# Memo

**Re:** Right-of-Way Encroachment Request - Vesha Law Firm (Case No. 12-083ROW)

12-083ROW  
Right-Of-Way Encroachment  
BSC Historic Core District - Vesha Law Office  
38 S. High Street

12-040ARB-MPS  
Signs, Site, and Architectural Modifications  
Vesha Law Office  
38 South High Street

**A** EXISTING SITE PLAN  
1' = 10'

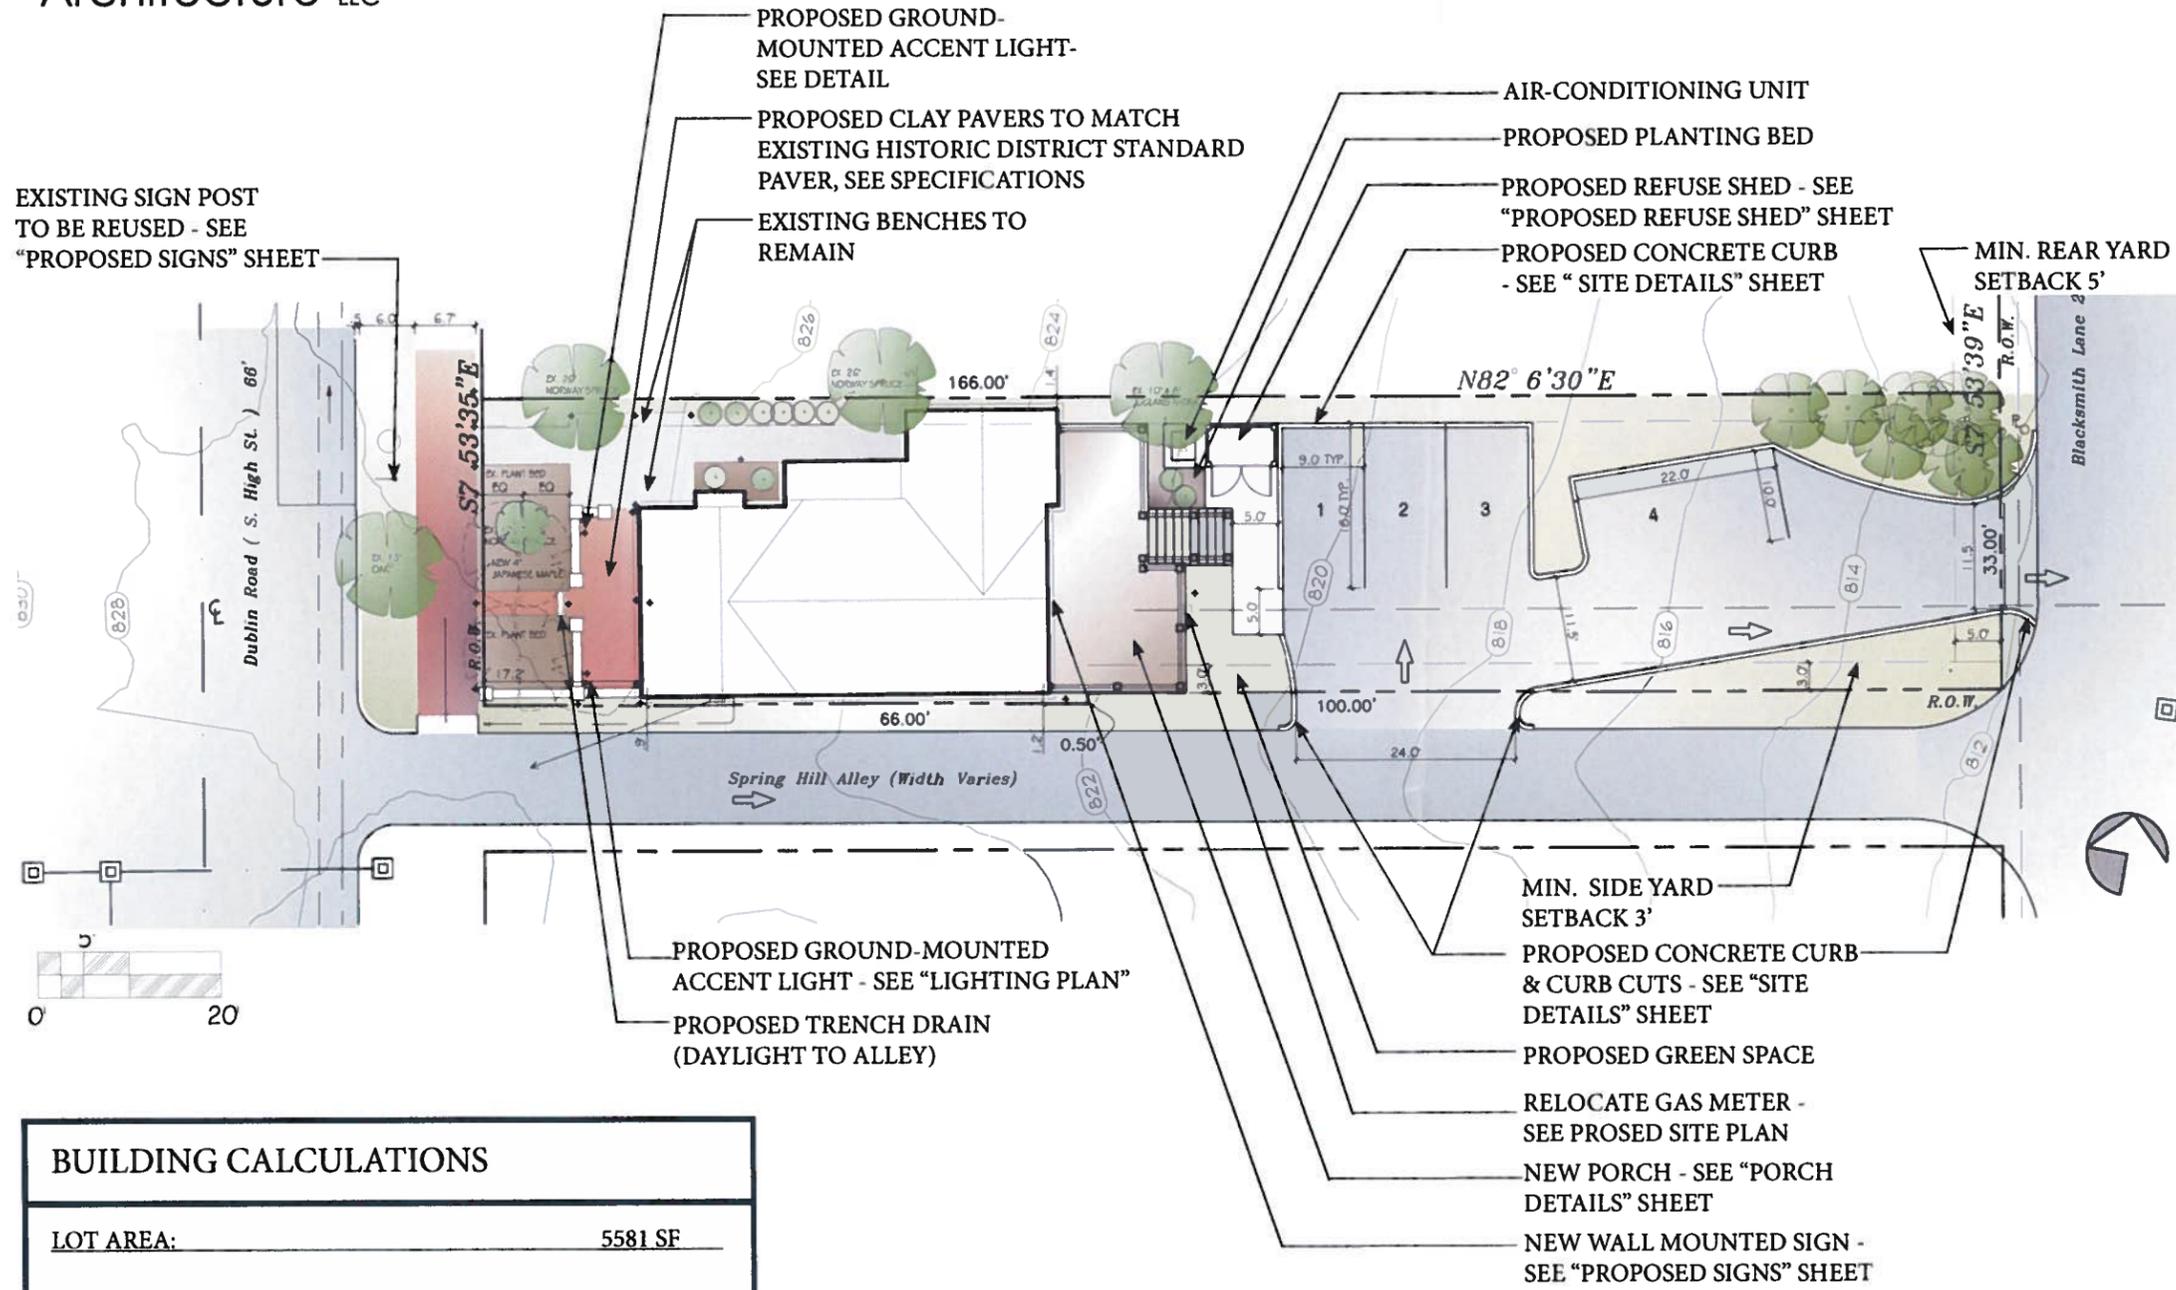
Ms. Martin said the Administrative Review Team worked with the applicant on the proposed parking lot modifications. She said that the applicant is required to provide five parking spaces based upon the use. She said four parking spaces have been accommodated on site with one on-street space in front. She said the entrance into the site from Spring Hill Lane has been reduced to 24 feet in width. Ms. Martin said curbing will be installed to provide protection for vehicles in the parking lot due to the grade change from the edge of the parking lot to Spring Hill Lane.

Five parking spaces are required for this use; the parking lot will provide a maximum of four parking spaces, with one on-street parking space counting toward the parking requirement. The applicant is proposing to reconstruct the existing asphalt parking lot to include perimeter curbing and clearly define parking spaces and the driveways to Spring Hill and South Blacksmith Lane. After considerable discussion on the parking lot design and function, an administrative departure was approved by the Administrative Review Team to allow a driveway width of 24 feet instead of 22 feet and reduce the parking lot drive aisle to 11.5 feet from 12 feet. The reconstructed parking lot reduces the amount of pavement currently on the site as well as delineating parking spaces previously not identified.

Ms. Martin said the curbing currently encroaches into the three-foot side yard setback on the north side of the lot, and the applicant will need to remove this encroachment when the parking area is reconfigured. She noted the drive aisle may need to be reduced to 11.5 feet in order to allow enough space, which could require an additional Administrative Departure.

Mr. Bogenrife said if the parking spaces were angled, then they would only have space for three, with one parallel space. Ms. Cox suggested centering the curb cut on parking space number two, which would provide more green space in the islands near the trees on the northeast portion of the lot. She confirmed vehicular access to the dumpsters was not needed on this site.

We are proposing to use public parking to meet the requirement for an accessible space. An on-site accessible space would require the installation of a very long ramp (over 90' of length to accommodate the grade change not to mention the additional landings required, because of the space constraints of the site). The only other option would be to provide a lift. The lift is not required by code, because the size of the building is under the threshold requirements for elevators. Based on these factors we are not providing an accessible parking space on site. There will be an accessible entrance on High Street.

**A** PROPOSED SITE PLAN  
1" = 20'

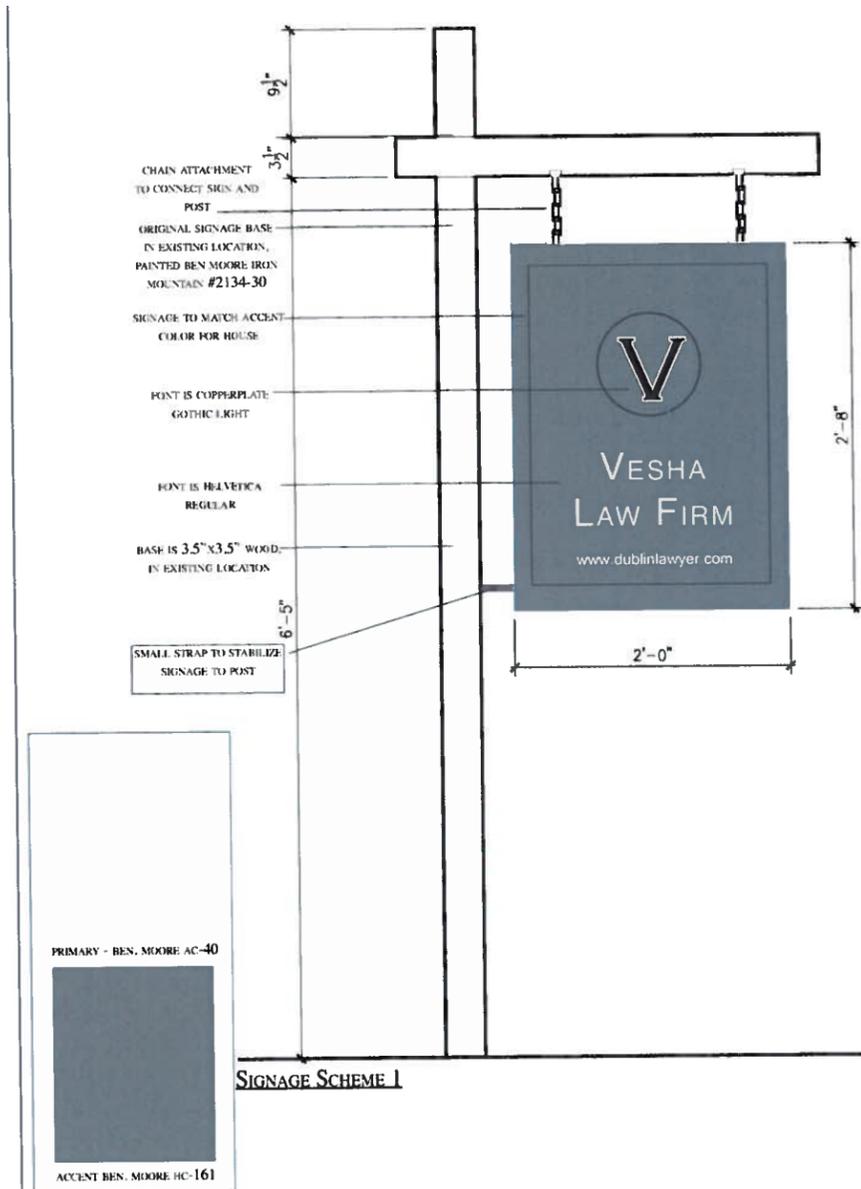
Ms. Martin said the applicant proposes to utilize the existing sign post located in the right-of-way along South High Street in the tree lawn and only replace the sign panel. She said wall signs are proposed over the front and rear entrances, utilizing colors that compliment the building. Ms. Martin said the applicant is proposing a trash enclosure for trash receptacles in the parking lot. She said the enclosure would be of the same materials and colors as proposed for the building.

- (a) **Similarity to Approved Basic Plan**  
*Not applicable*
- (b) **Consistency with Approved Development Plan**  
*Not applicable*
- (c) **Meets Applicable Zoning Regulations**  
*Met through condition.* The proposed architectural modifications are consistent with the requirements of the Zoning Code for primary building materials and individual building type requirements. As conditioned, the proposed signs are consistent with the Zoning Code requirements for signs in regards to location, number, height, area, and design. The proposed ground sign is located within the right-of-way and will require a right-of-way encroachment.

*Criterion met through condition:* The proposed wall signs are architecturally integrated and will appropriately add to the variety sign designs in the Historic District. The proposed ground sign is located within the right-of-way and will require a right-of-way encroachment permit from City Council.

Engineering has reviewed the plans and approved the request, finding that the sign meets the requirements for approval, and a hold harmless agreement has been received. The City Engineer and Planning recommend Council approval of the Right-of-Way Encroachment request.
